SI B63 07 18  
Lights

## TAILGATE LIGHT CRACKED

G01 (X3)
Produced from 8/1/2017-12/21/2018

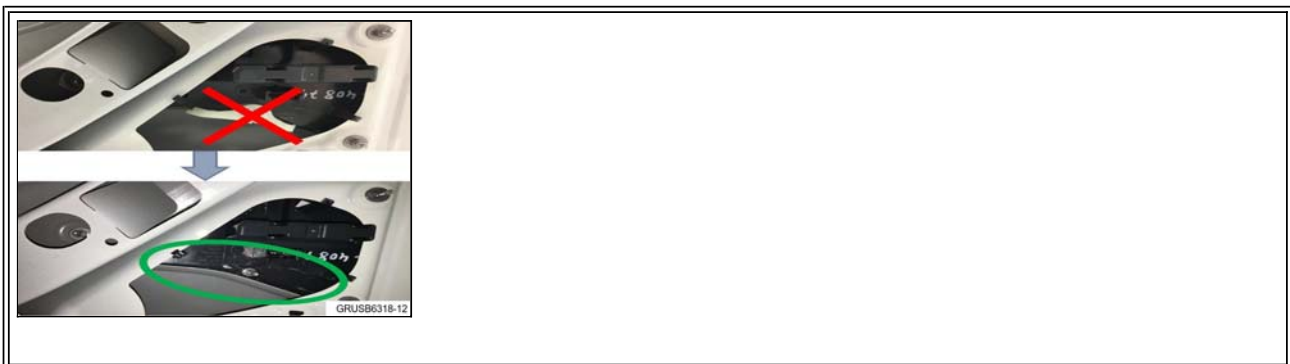
Cracks may be present in the rear lights mounted to the tailgate.

### CAUSE

Stress caused by an additional mounting bracket.

During installation, do not re-install the lower mounting bracket shown below. This will reduce the stress that is causing the cracks to occur.

Replace cracked rear lights with modified installation instructions.

Note: When replacing only one light, remove the bracket from the other installed light as well. Ensure

both rear lights do not have a mounting bracket installed.
